Centennial Coal

RESPONSE TO SUBMISSIONS

**Western Coal Services Project
State Significant Development 5579
Modification 1**

February 2017

Figure 2-1 Cumulative probability distribution – LDP006 salt load

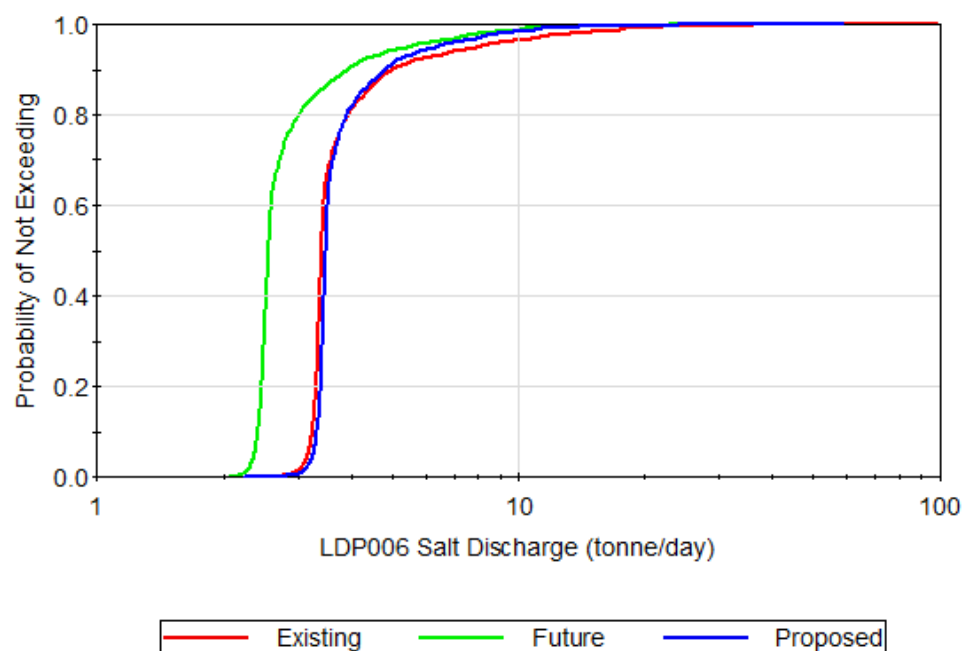
In response to requests to assess the salt loads in the most extreme (rare) of discharge events, probability of daily salt loads have been provided in Figure 2-1 and numerically in Table 2-1 within Section 2.1, modelled as part of the water and salt balance assessment (GHD, 2016a). The predictions indicate that in rare events, the daily salt loads reduce for proposed conditions compared to existing conditions. Considering a daily salt load of 10 tonnes/day the probability of not exceeding this load for the proposed conditions were predicted to be 99% of days compared to the existing conditions, which were predicted not to occur within 97% of days.

Figure 2-1 indicates that the salt load between the existing and proposed modelled scenario to be comparable, specifically in the rarest of occasions, with the proposed scenario likely to result in a salt load slightly less than the existing case. In terms of the numeric results at specific percentiles, these are provided in Table 2-1 below.

Figure 2-2 Baseline monitoring of EC in shallow groundwater environment (GHDA 2016)

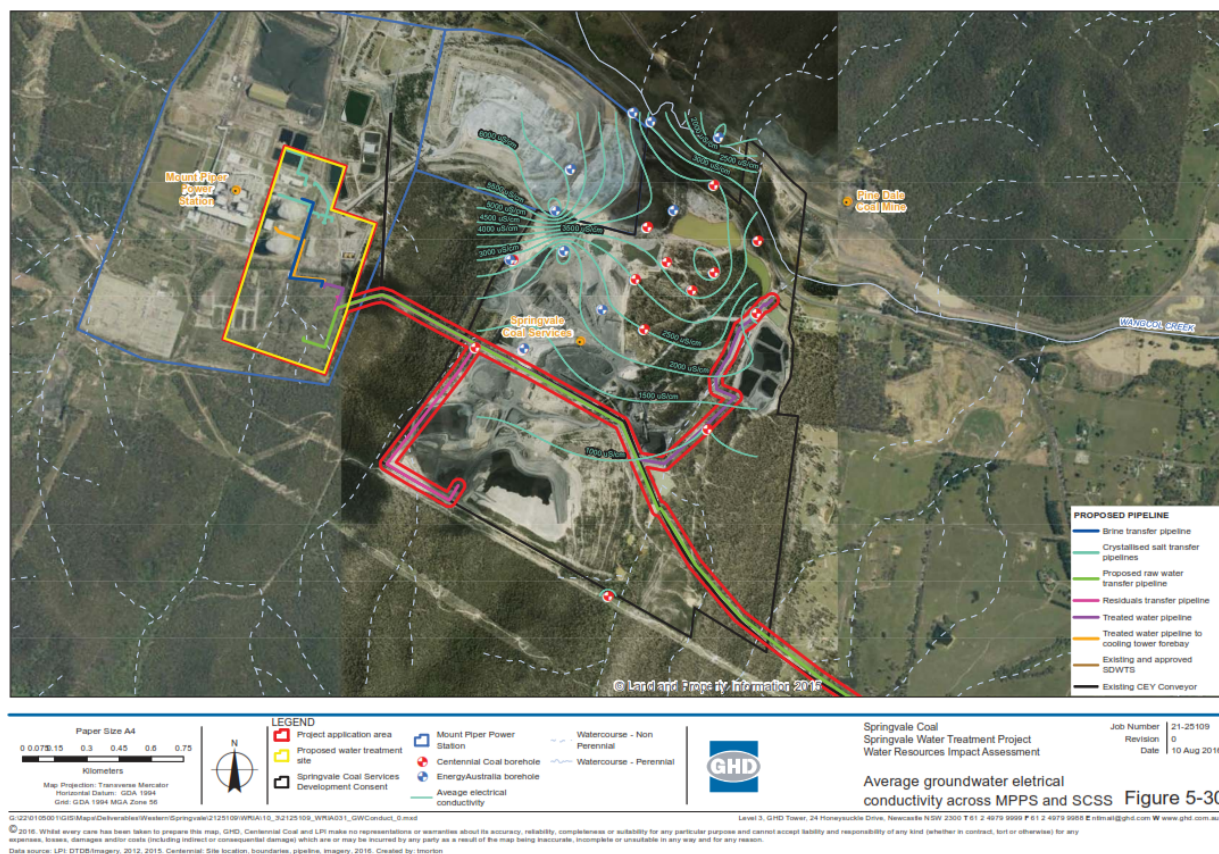
The pre-treatment residual material would contain a range of metals. It is unclear in the SEE what the sequencing of emplacement would be and how the emplacement would be managed to limit the risks associated with shallow groundwater resources. Please provide further details on how the risks of this impact would be minimised.

There is a cyclic relationship behind water sourced for washing from Cooks Dam and the disposing of reject material within the REA, with pathways of water back to Cooks Dam. This cycle is likely to result in some concentrating effects; however, groundwater quality data indicates other areas of high EC water are influencing water quality in the locality. Figure 2-2 presents the EC from the groundwater environment presented by GHD in the impact assessment for the SWTP (GHD 2016c).

A potential mitigation measure to cease infiltration function from occurring would include lining of surface infrastructure at the SCSS, including the new REA and A-Pit REA. However, the majority of the surface infrastructure at the SCSS are already operational and retrospectively lining would be impractical and inefficient considering the extent of surface to groundwater connectivity known to exist.

Figure 4-1 Cumulative probability distribution of discharges via LDP006

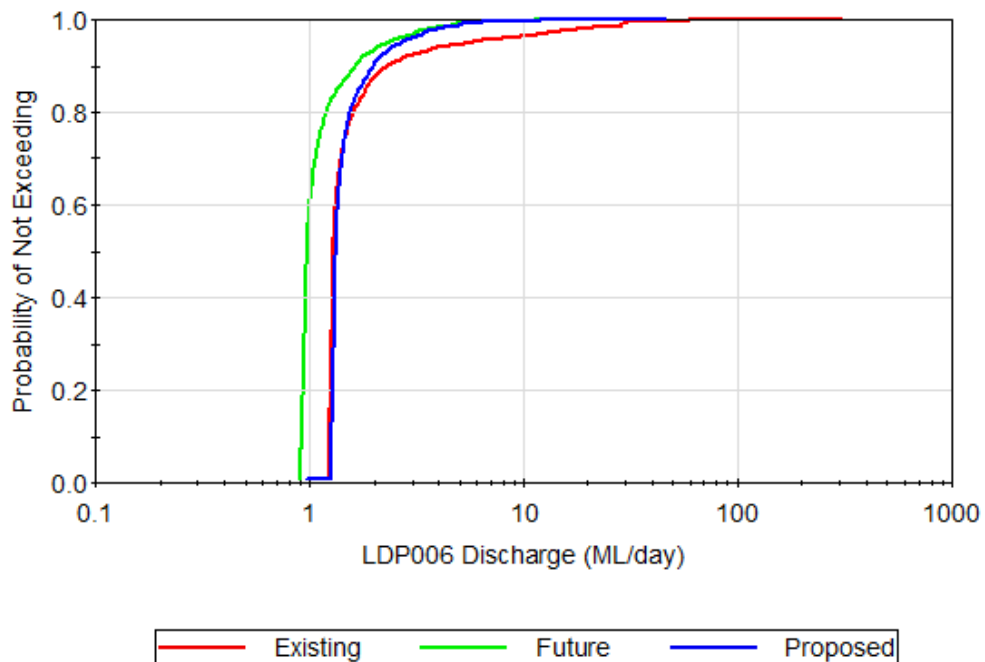
Emplacing the pre-treatment process residual waste could increase the LDP006 daily discharge rate. The increased discharge is modelled on an annual average basis. Please provide details on the maximum increase in discharge, and what effect this maximum would have on the receiving environment.

From Figure 4-1, it is clear that the maximum flow at LDP006 is greatest for the existing conditions modelled, due to the fact that all catchment area is contributing to this discharge point. The results indicate flow rates between 4 ML/day (90th percentile) to 59 ML/day (100th percentile) from the model for the existing conditions. In comparison, the future and proposed scenarios indicated a reduced discharge volume due to the diversion of catchment away from LDP006. This indicated a potential 100th percentile result of less than 12 ML/day for both scenarios. These events would most likely occur when significant rainfall is occurring and the dirty water management system at the SCSS has its capacity exceeded resulting in water surcharging to LDP006. It is estimated that the dirty water management system (of the future and proposed condition scenarios) will operate to criteria of conveying a 20 to 50 year average recurrence interval (ARI) event, after which the dirty water system would overflow into the clean water network.

A comparison of the results of the future and proposed condition illustrate the effect that the residual load has on daily flow rates. Figure 4-1 shows that residual influence occurs up to approximately an 80th percentile, of which greater than this rainfall becomes a greater influence on the effect of discharges at LDP006.

Figure 4-3 Main Sediment Dam – EC levels from 2013 to 2015

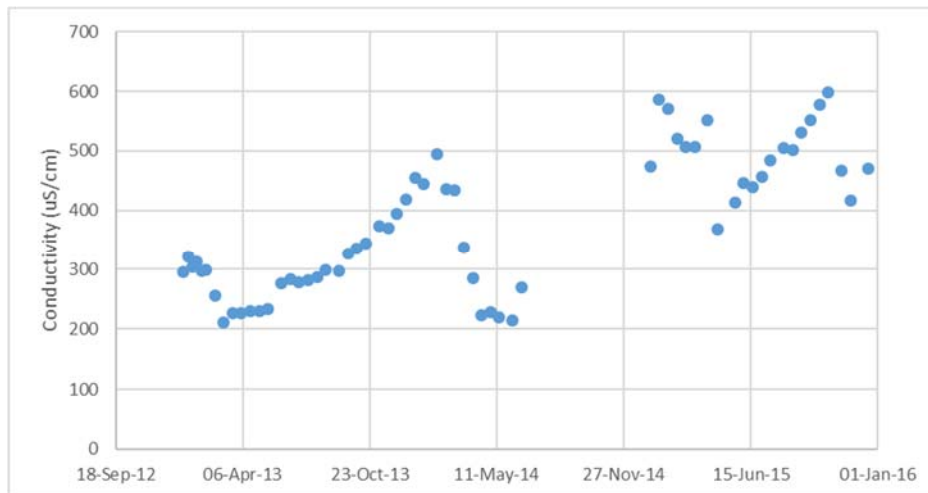
Clean water diversions are currently being installed at the site, with the most significant works relating to the diversion of clean water overflows from Retention Dam away from LDP006. Please provide details on the proposed drainage path of the overflows, detail the timing of installation of all clean water works, and how these works would contribute to improvements to water quality impacts.

Figure 4-3 shows the elevated salinity present within Main Sediment Dam, a clean water dam over the last two years. The data indicates that the salinity levels for potentially disturbed catchments are not related to coal works or handling.
